**Statement of Response to ABP's Opinion
in relation to Reg. Ref.: ABP-301098-18**

**Issues Raised During the Course of
Pre-Application Consultation**

A Proposed Strategic Housing Development

Glencairn, Murphystown Way, Dublin 18

Figure 2: Revised proposal submitted to the Department of Culture, Heritage and the Gaeltacht, with the archway, gates, flanking walls and railings, to be relocated

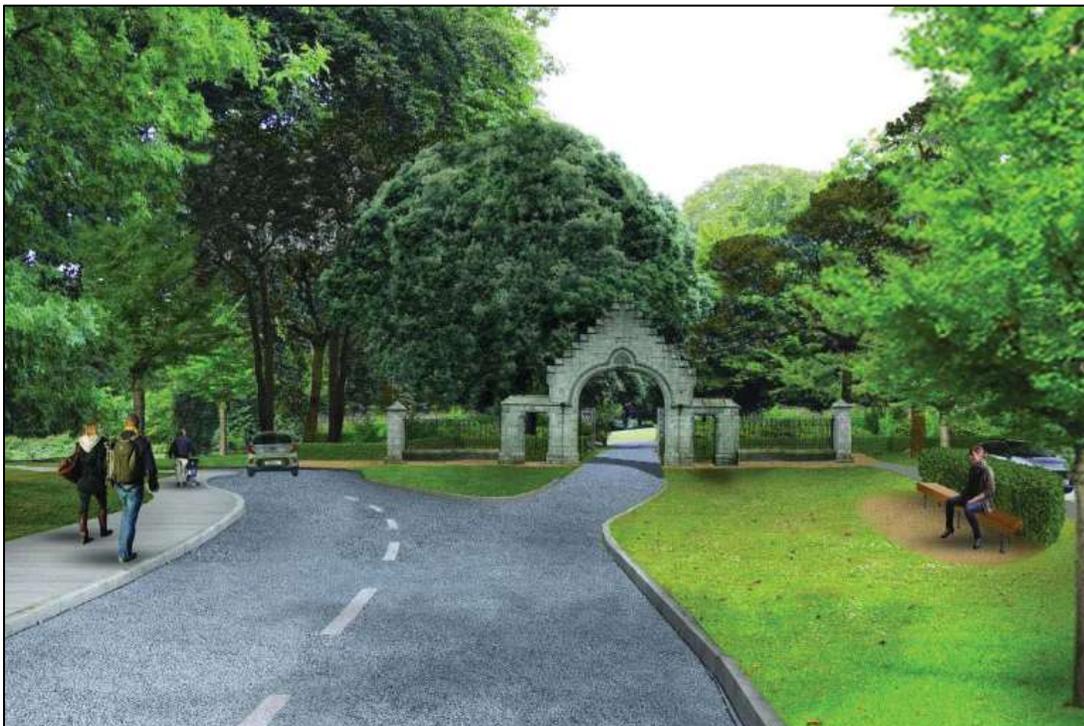
Ms. Roche subsequently reverted acknowledging the requirement in principle for relocating the entrance portal, however, concerns were outlined in relation to proposal to relocate only part of entrance portal and associated structures, and in respect to the proposed new location relative to the permitted new boundary wall and secure entrance to Glencairn House.

Further comments on this revised proposal were received from the DCHG thereafter, suggesting the reorientation of the relocated entrance portal and amendments to the landscaped setting for this feature.

Based on these final comments, the design team further amended the orientation, location, and landscaped setting of the relocated entrance portal and associated features. This final proposal was then submitted to the Department, with the Department confirming informally thereafter that the final proposal addressed the issues raised in previous consultation.

Therefore, in response to this Item of the Board's Opinion the final application includes revised proposals for the entrance portal relocation, which now includes for the relocation of the archway, gates, flanking walls and railings, from the existing location at the entrance to the site, to a new location at the mouth of the proposed new junction to a retained section of the existing entrance avenue to Glencairn House.

Figure 5: Railing type proposed at Murphystown Castle (refer to BSM Drawing No. 6290-303)

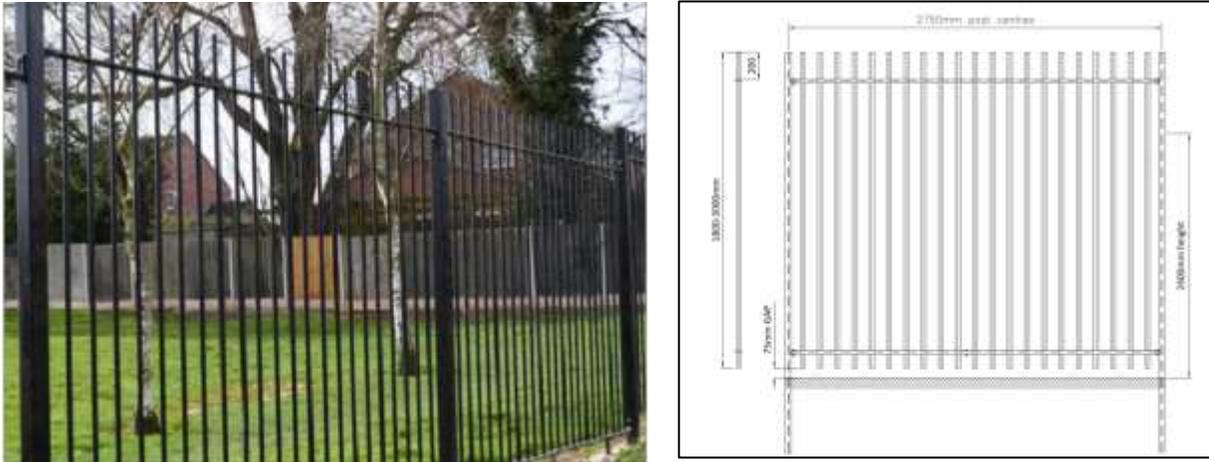
The design team considered the recommendation of the Conservation Officer in respect of the fencing proposed in the vicinity of Murphystown Castle. The DLR Opinion, at the 'Archaeology' section, recommended that the proposed railings around the castle be substituted for an estate type railing as indicated on BSM drawing no. 6290-311.

While this recommendation was given due consideration, it was concluded that the fencing originally selected would be best suited to this location within the scheme. This is based on the requirement that the castle ruins be appropriately secured, to avoid interference, vandalism or risk of injury, as they are located centrally within the proposed public open space. Estate type railings would not provide for this requisite level of security.

It is considered that the railing type proposed at the castle provides for sufficient security while maintaining views of the castle. This is demonstrated by the CGIs and drawings prepared by Brady Shipman Martin, which include reference photographs of the fence type proposed.
